LASER INTERFEROMETER GRAVITATIONAL WAVE OBSERVATORY

Document Type	DCC Number	January 15, 2009
	T0900014-v2	
UK UIM Coil Driver Pre-Production Prototype Bench Test and Evaluation		
J. Heefner, T. Etzel

Figure 1: UIM Preproduction Prototype (PP) Chassis Front View

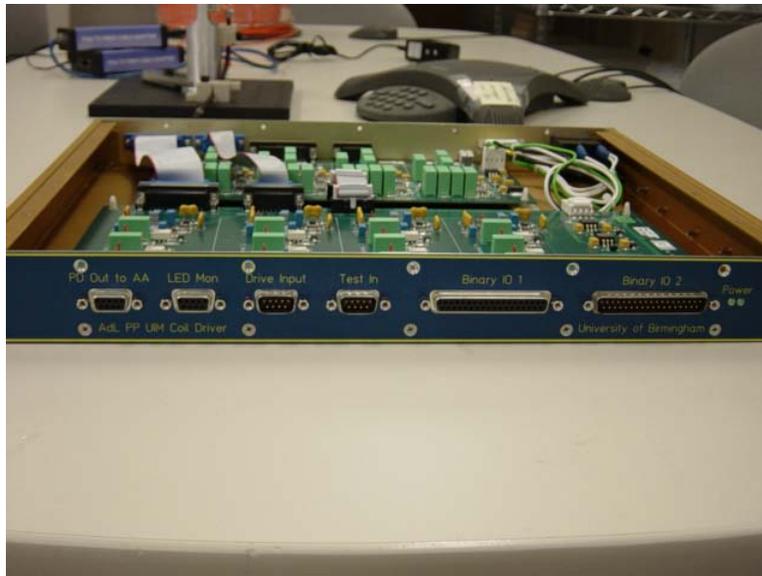
As can be seen from the photos, front and rear panel panels are professionally manufactured and all connection clearly labeled. The serial number for the chassis appears on the back panel and is applied using a label maker. This should be acceptable for production units.

Figure 5: UIM PP Driver Board

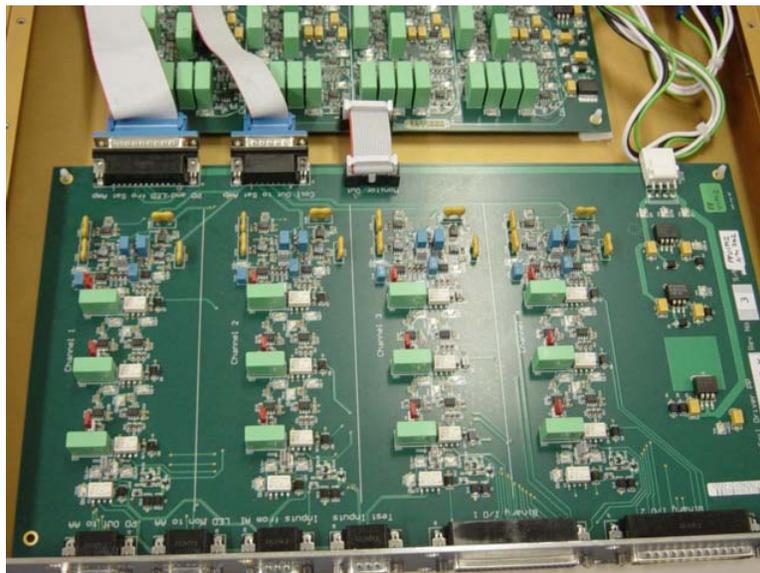
The photo below is a closer view of the UIM Driver board. As can be seen from the picture, the circuit board is multi-layer, professionally manufactured circuit board. Each channel of the circuit board flows from the front to the rear of the chassis and appears to have been produced using the multi-channel design features available in Altium. This is a very efficient and convenient way to produce designs that utilize the same circuit topology for multiple channels. When this feature is used, the logical designators for each component in the design are the same since the channel number portion of the physical designator is suppressed on the silkscreen. Each channel of the design is clearly labeled and designated on the silkscreen of the board.

Figure 6: UIM PP Monitor Board Jumper Wires

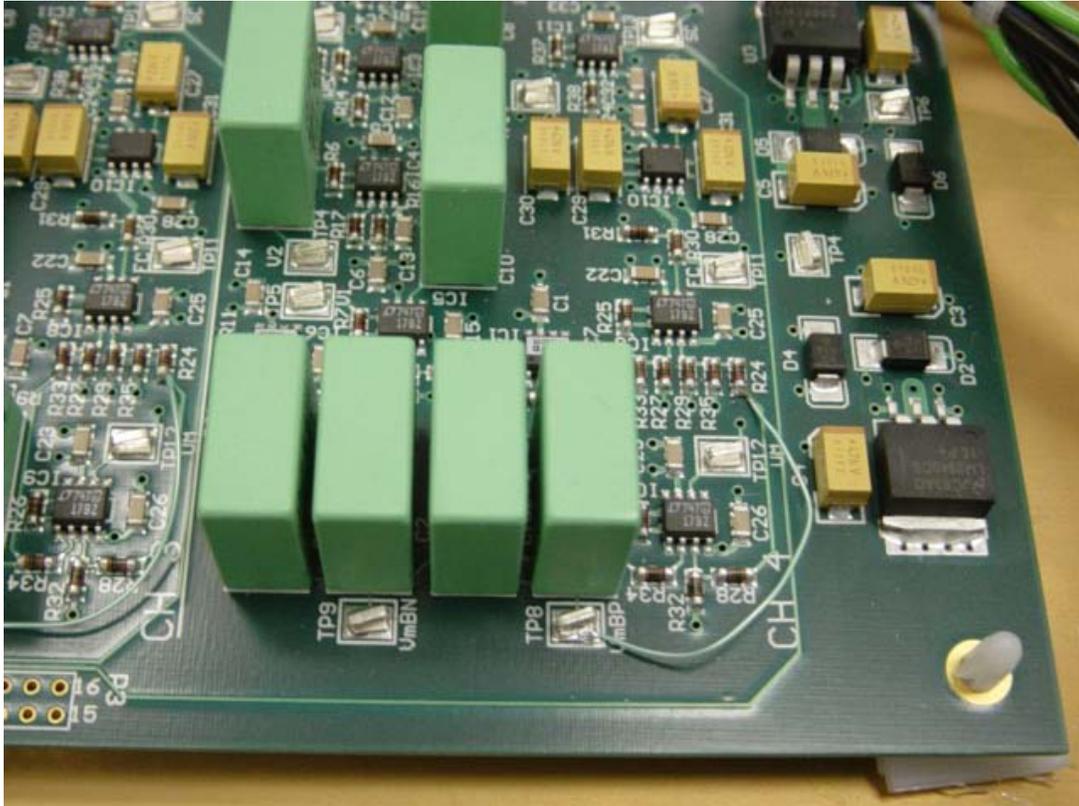
- The jumper wires on the monitor board used to correct a layout problem (see figure 6 below) represent a possible failure mechanism. If the layout of the monitor board is not corrected prior to production, a more robust means of attaching and securing the jumper wires needs to be devised.

The Monitor board was manufactured in a similar fashion and the only circuit board issues observed are the wires added from TP8 to R24 of each channel. These wires were added after circuit board

manufacture to correct an omission. It should be noted that one of these wires was broken free on the R24 end of the connection during shipment from the UK to the US. Prior to testing this connection was repaired. Production models of the Monitor board should be corrected so that these wires are not necessary. Both boards (driver and monitor) are identified in the space provided with the drawing number, revision number and serial number for the board. The circuit board (pcb artwork) revision number is included on the silkscreen for each board.

Figure 8: Noise Monitor Transfer Function, Measured from Driver Input to Monitor Output

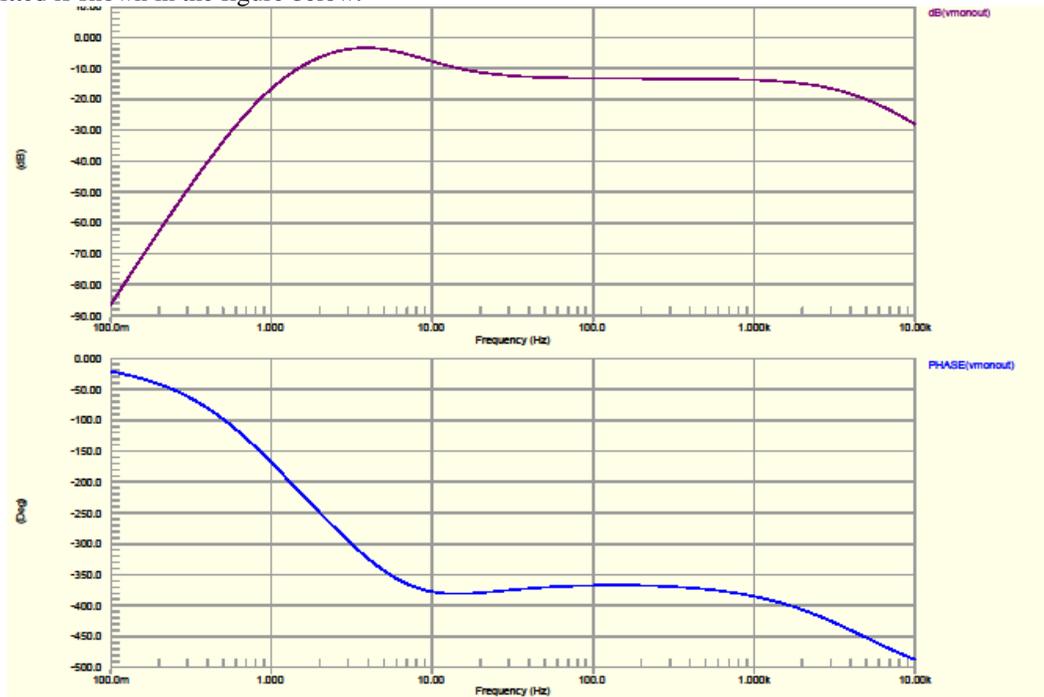
The transfer function from the input of the driver to the output of the noise monitor circuit was measured in section 3.5.1 of the test plan. A plot of the expected transfer function for the design submitted is shown in the figure below.

The measured transfer functions for all four channels were found to be in close agreement with the Altium simulation.
